**TOWN OF LOS GATOS  
CONCEPTUAL DEVELOPMENT ADVISORY COMMITTEE  
FEBRUARY 12, 2025  
110 EAST MAIN STREET  
TOWN COUNCIL CHAMBERS  
4:00 PM**

2. Consider a Request for Preliminary Review of a Proposal for Subdivision of One Lot into Three Lots on Property Zoned HR-2½. **Located at 401 Surmont Drive.** APN 527-20-002. Conceptual Development Advisory Committee Application CD-24-001. Property Owner: Srikanth Kasa. Applicant: Jason Chan. Project Planner: Ryan Safty.

SUBJECT: Consider a Request for Preliminary Review of a Proposal for Subdivision of One Lot into Three Lots on Property Zoned HR-2½. Located at 401 Surmont Drive. APN 527-20-002. Conceptual Development Advisory Committee Application CD-24-001. Property Owner: Srikanth Kasa. Applicant: Jason Chan. Project Planner: Ryan Safty.

Residence locations in Submission rev1 + houses [8] are roughly placed based on the light green LRDA areas shown in image BATE 3 LOT YIELD [5].

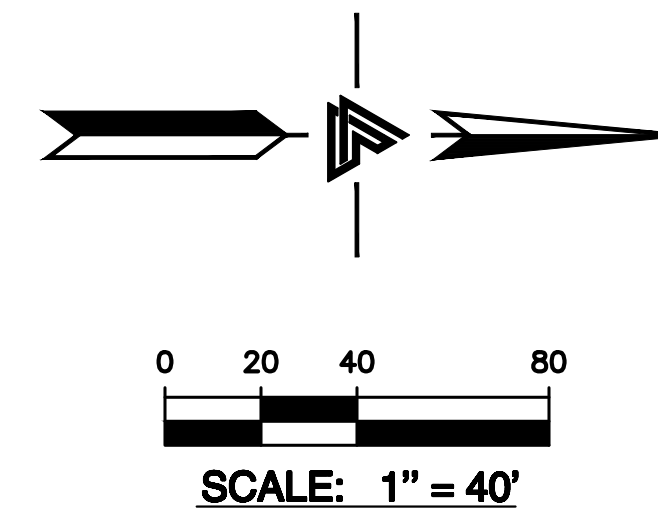
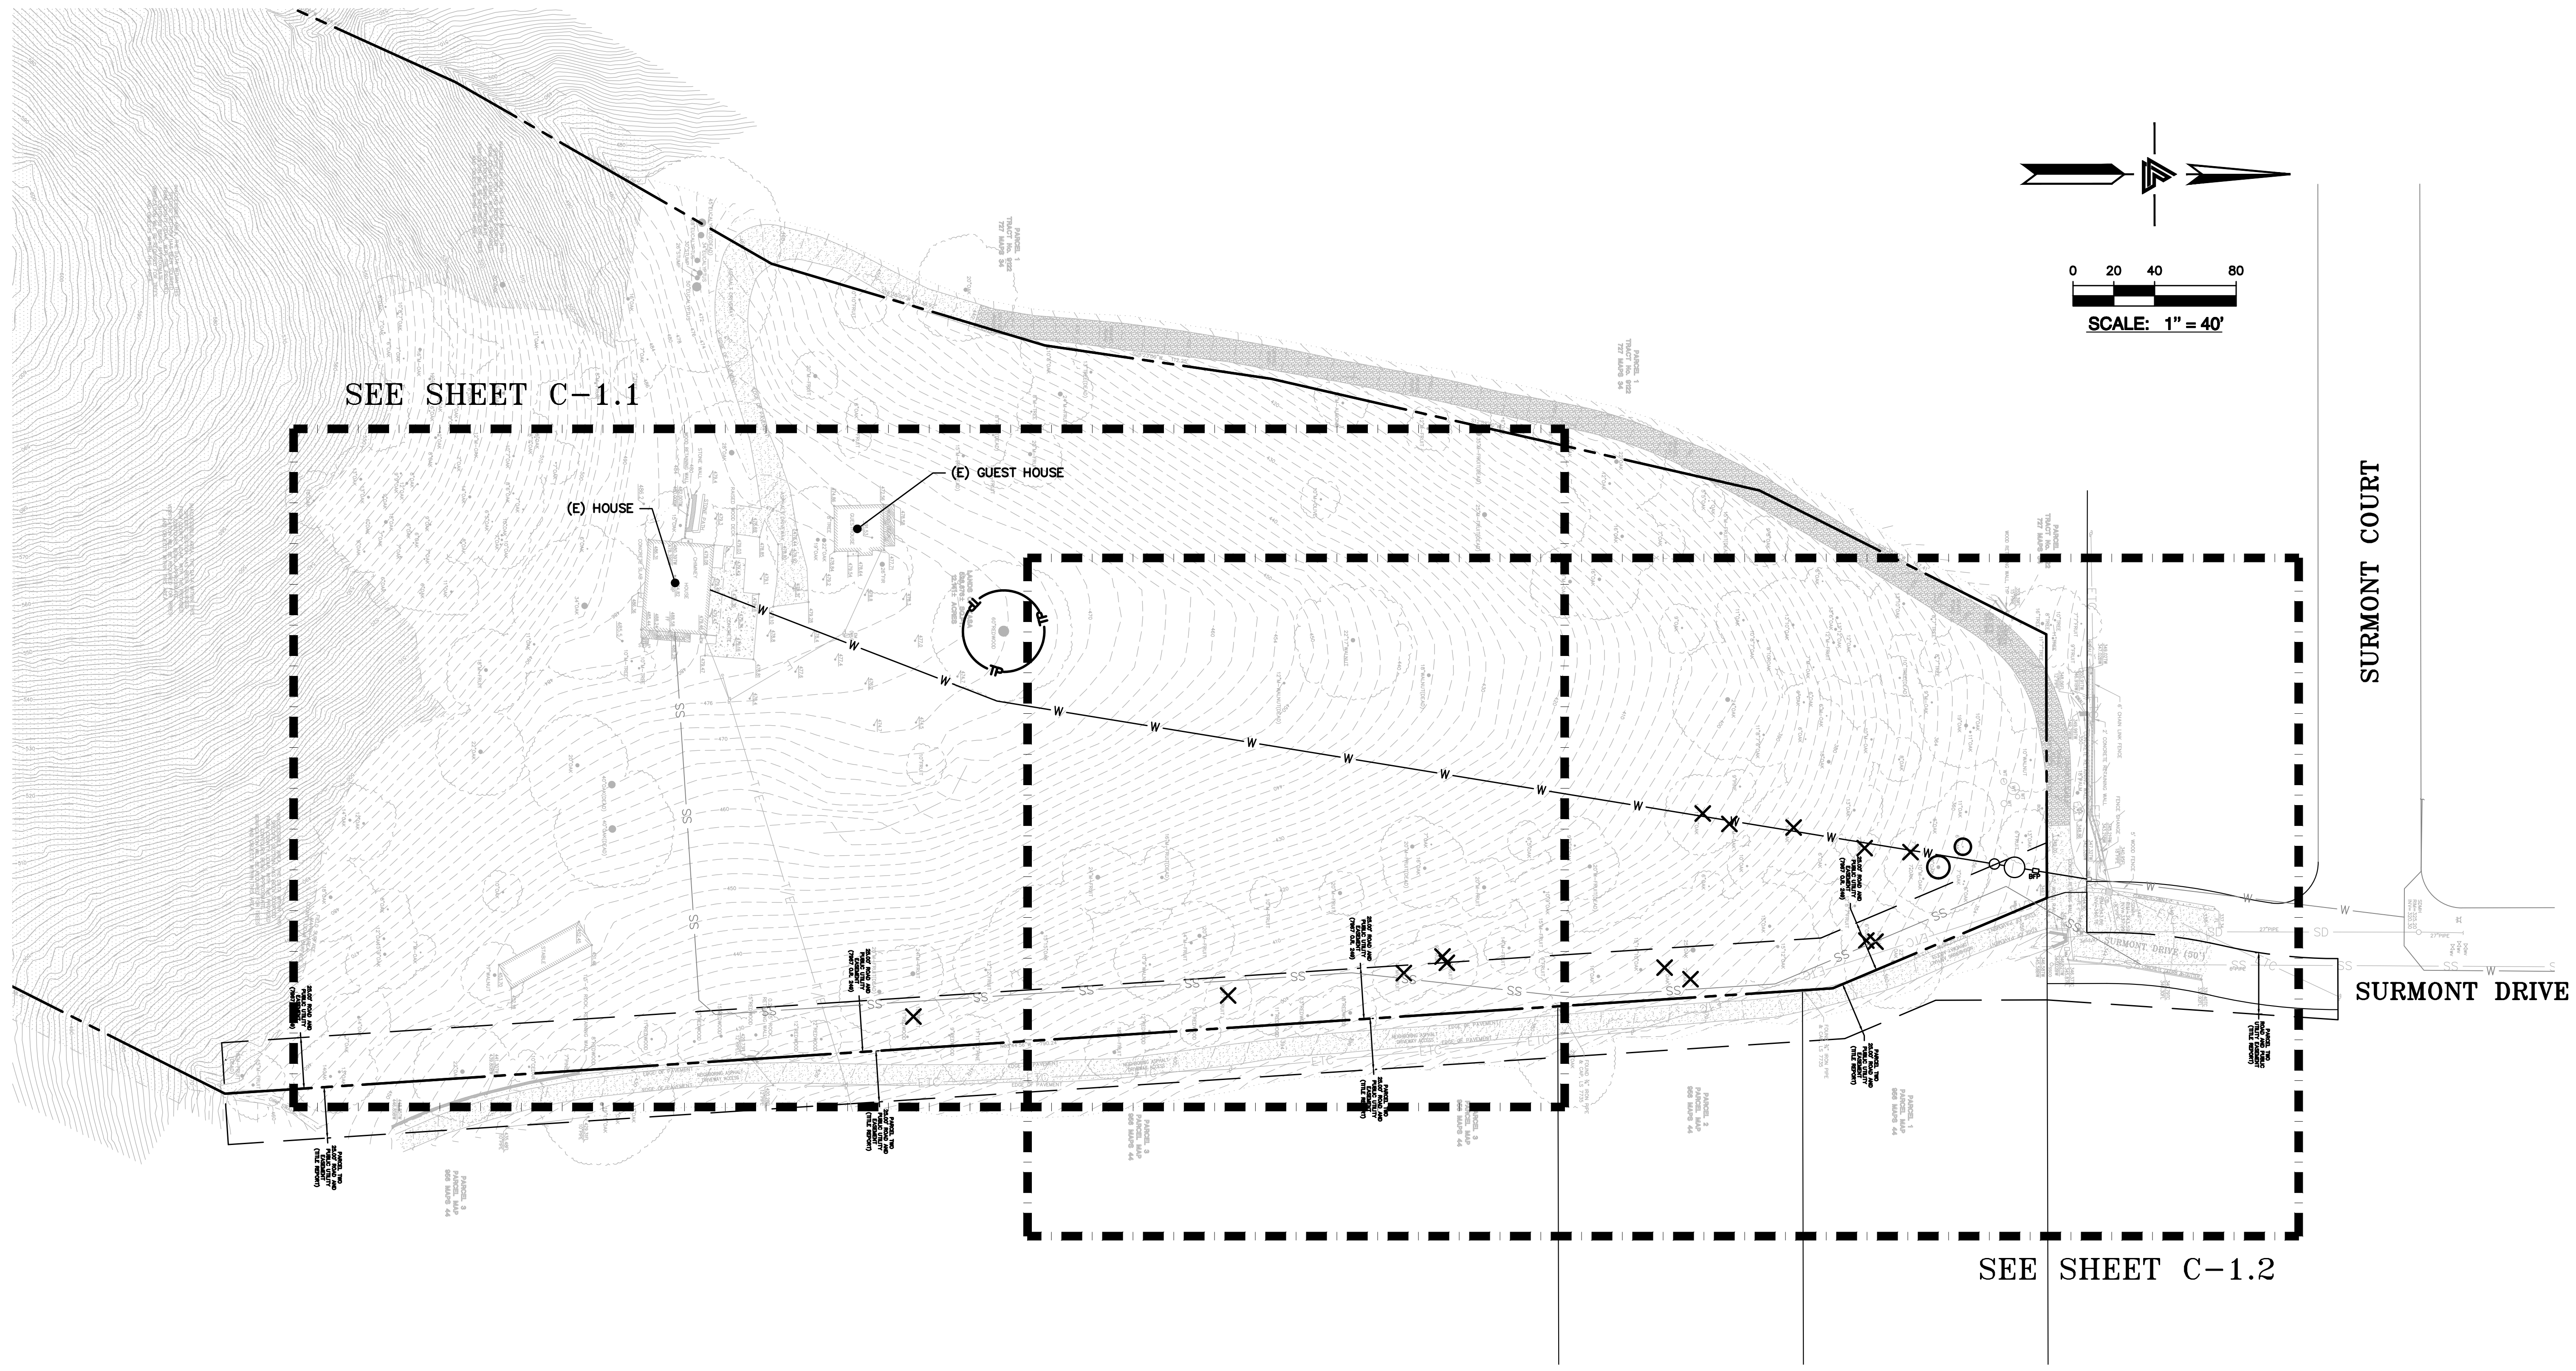
Would the CDAC approve a larger-than-standard parking structure at the base of Lot 3, and a trolley connecting the residence to the structure, even if the slope exceeds 30%?

Least Restrictive Development  
Area (LRDA)

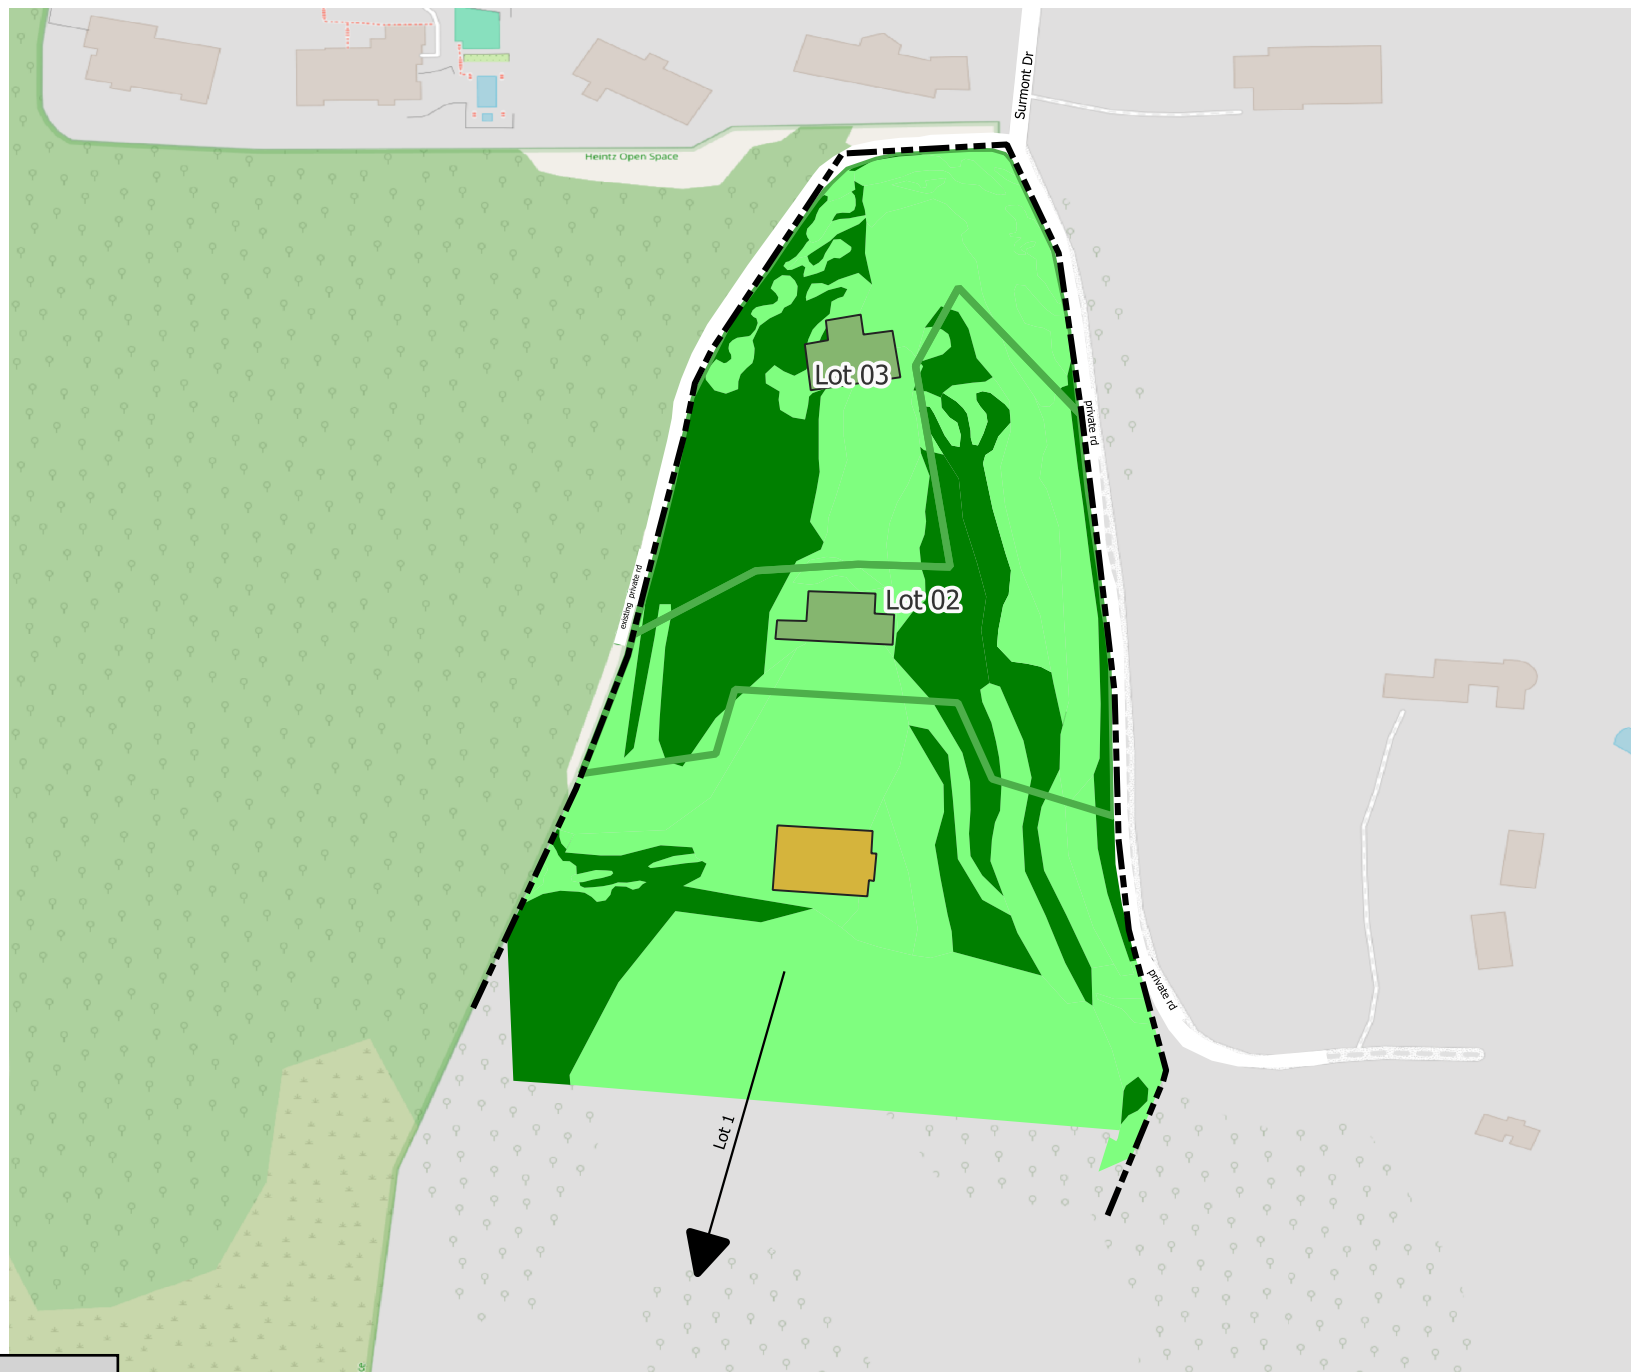
- a. Any new construction or grading on this property must be reviewed for compliance with the Town's Hillside Development Standards and Guidelines (HDS&G), including but not limited to: maximum cut and fill amounts; construction within the Least Restrictive Development Area (LRDA); retaining wall heights; exterior colors; etc. As noted in Attachment 3, exceptions to the cut and fill standards would be required for the Santa Clara County Fire Department (SCCFD) roadway requirements. The conceptual building footprints in Attachment 5 show that only the Lot 2 footprint would be fully within the LRDA.
